**RE: AFD Fire Station 12
11714 Linn Ave. NE
Grading and Drainage Plan
Engineer's Stamp Date: 8/9/24
Hydrology File: L21D036**

AFD FIRE STATION 12

OVERALL GRADING AND DRAINAGE PLAN

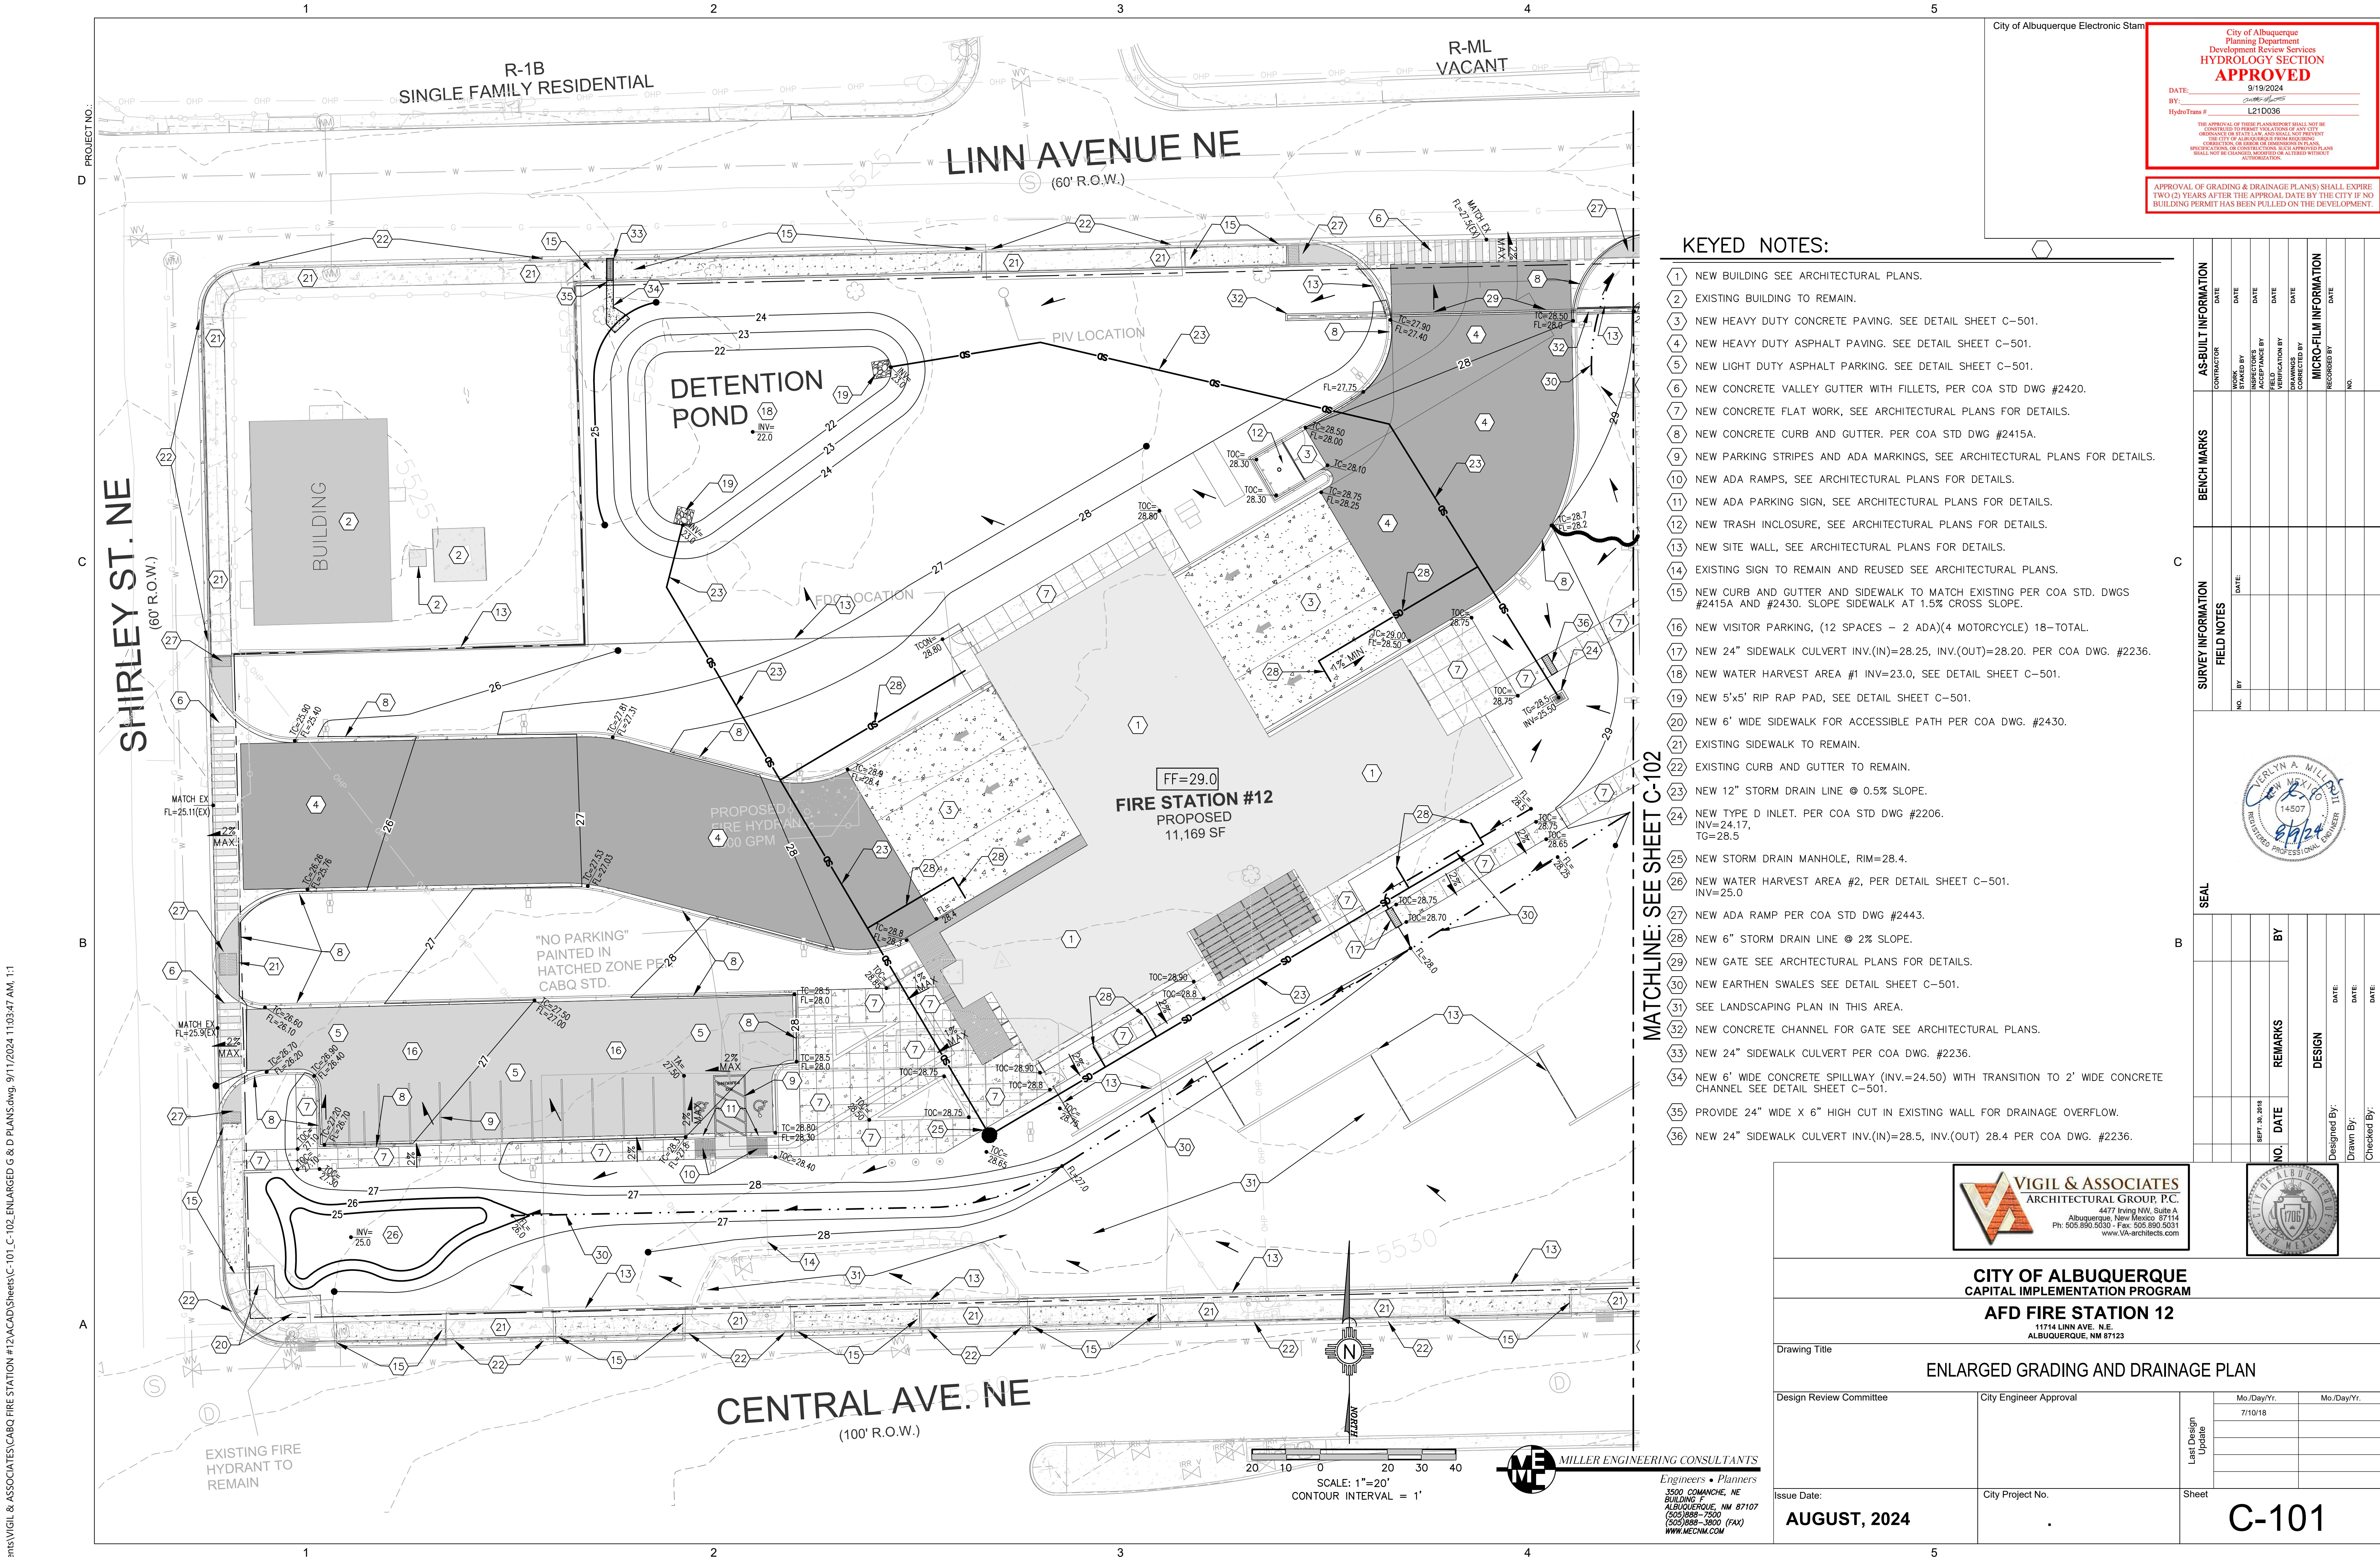
Based upon the information provided in your submittal received 09/11/2024, the Grading and Drainage Plan **is approved** for Grading Permit, Building Permit, and Work Order. Please attach a copy of this approved plan in the construction sets for Building Permit processing.

Engineer's Certification, per the DPM Part 6-14 (F): *Engineer's Certification Checklist For Non-Subdivision* is required.
